RE: Project 2018-0087 Response to Information Request - SVI

The Government of Yukon, Assessment and Abandoned Mines Branch (AAM) has received and reviewed the October 4, 2018 information request and has compiled responses to the requested information in this letter. The questions are provided in advance of responses for context.

Figure 1: Victoria Creek Upstream of Minnesota Creek (VC-UMN) – measured and modeled hardness and corresponding hardness-based sulphate guideline (Table 2-2).

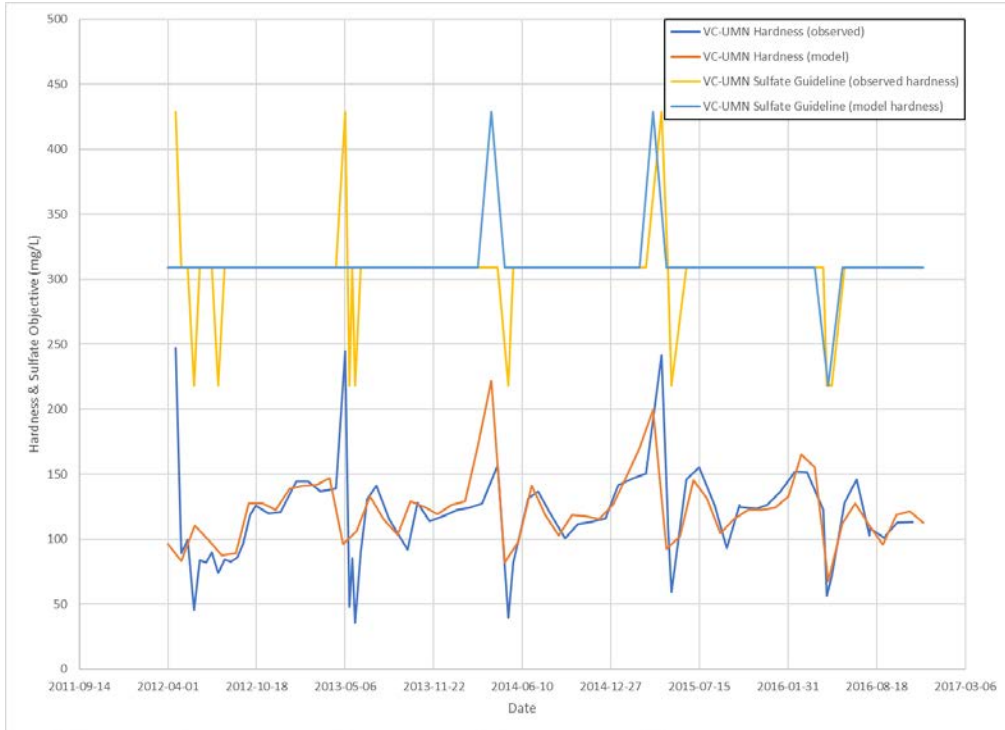
1. *[ECCC 2018-0087-069-1 and LSCFN 2018-0087-072-1] The WTP is reported to be beneficial “for the removal of secondary parameters of interest including aluminum, arsenic, cadmium, and zinc with some benefit to manganese.” The WTP is also intended to address elevated sulphate found in the tailings seepage collection pond. The bench scale test results do not seem to support this conclusion. For example, both dissolved and total manganese increased as a result of the bench scale test (5.88 mg/L to 6.34 mg/L and 6.21 mg/L to 7.19 mg/L respectively for dissolved and total manganese). Sulphate, zinc, and cadmium also either increase or show minimal reduction between influent and effluent concentrations as a result of the bench scale testing (e.g. sulphate increased from 696 mg/L to 744 mg/L and total zinc increased from 0.02 mg/L to 0.03 mg/L). Moreover, proposed water quality objectives for sulphate in Victoria Creek is cited as 429 mg/L in section 7.3.3.4.5, while table 7.3-6 cites a sulphate WQO of 309 mg/L. More details about the water quality objectives are provided in Appendix 7A where the objective for Victoria Creek appears to be cited as 218 mg/L.*

a) *Clarify the water quality objective for sulphate in Victoria Creek*

Based on historic data from 2012 to 2016, observed hardness in Victoria Creek at VC-UMN (downstream of Dome Creek) has ranged from 36 to 248 mg/L (Figure 1). The corresponding sulphate WQO would therefore have ranged from 218 to 309 to 429 mg/L, depending on the observed hardness (Figure 1). Calculated model estimates of hardness are comparable to the range of observed hardness levels for the 2012-2017 data set, as shown in Figure 1 below. Note that both the observed and modeled sulfate concentrations for this timeframe are well below their respective, calculated, hardness-based WQO (Figure 2).

There is some inconsistency in the application regarding the stated WQO value for sulphate. For example, the sulphate WQO in Section 7.3.3.4 of the project proposal (*Ecological Objectives of Valued Components*) is 309 mg/L (Table 7.3-6 of the project proposal). Meanwhile, the text in Section 7.3.3.4.5 of the project proposal (*Sulphate*) states the sulphate WQO for Victoria Creek is 429 mg/L. This inconsistency is due to the corresponding different hardness values that were used to derive the stated WQO value, which ranges from 218 to 309 to 429 (as described above and as shown in Table 2-2 and Figure 1).

For clarity, the proposed sulphate WQO for Victoria Creek is consistently the hardness-dependent BC Guideline (Table 2-2) throughout the project proposal, which varies as a function of hardness. In this regard, the examples provided in question 1 of the request for information (i.e., Section 7.3.3.4.5, Table 7.3-6, Appendix 7A) would benefit clarifying footnotes that read: **the sulphate WQO for Victoria Creek varies with hardness, as per the British Columbia Water Quality Guideline (2013).*
